April 29, 1994  
LD-94-030

Docket No. 52-002

Subject: System 80+™ Information for Issue Closure

The attachments to this letter provide revisions to CESSAR-DC and comments on the System 80+ FSER. Attachment 1 provides marked-up CESSAR-DC pages resulting from our internal consistency for the new source term. These revisions are not significant, but should be given to Mr. J. Lee. They will be formally printed in Amendment W.

Figure 6.5-5

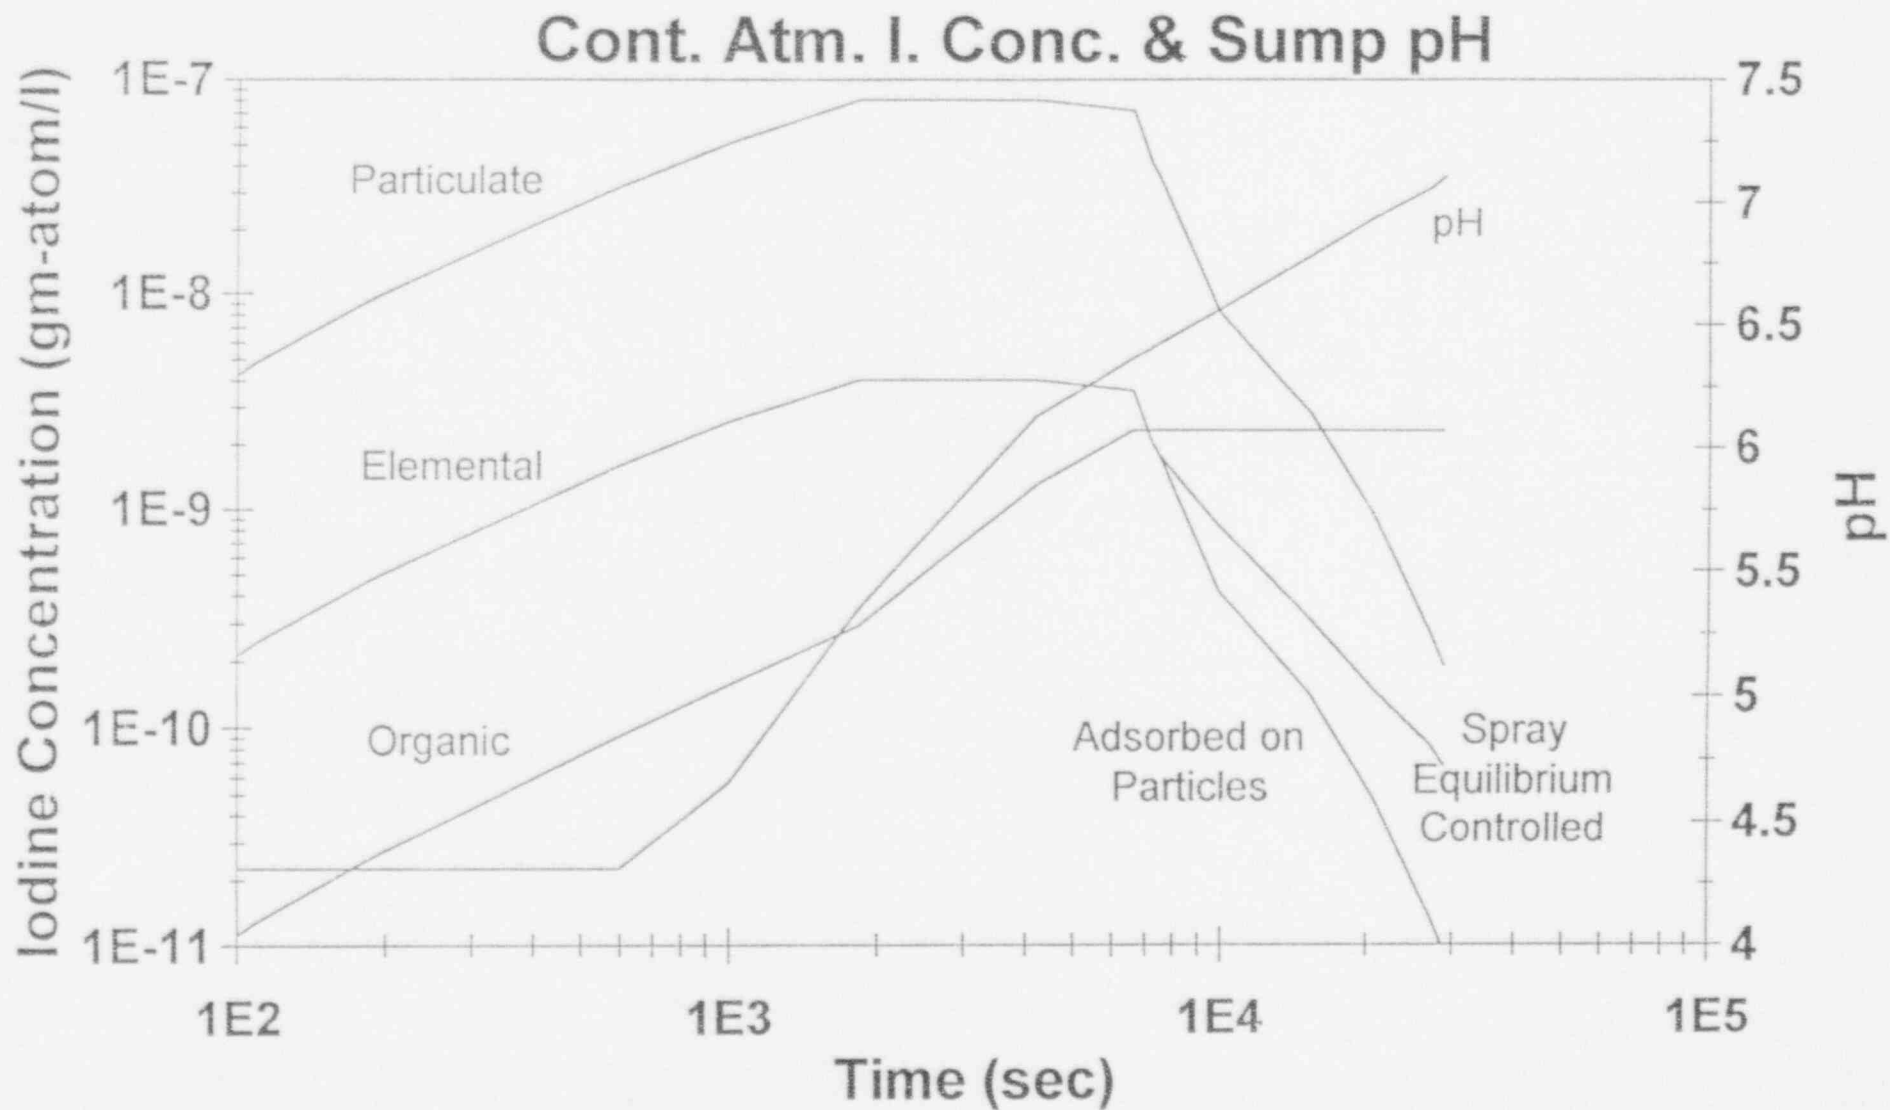
The transient spray removal lambdas for the 10CFR100 LOCA analysis are shown on Figure 6.5-5. 6
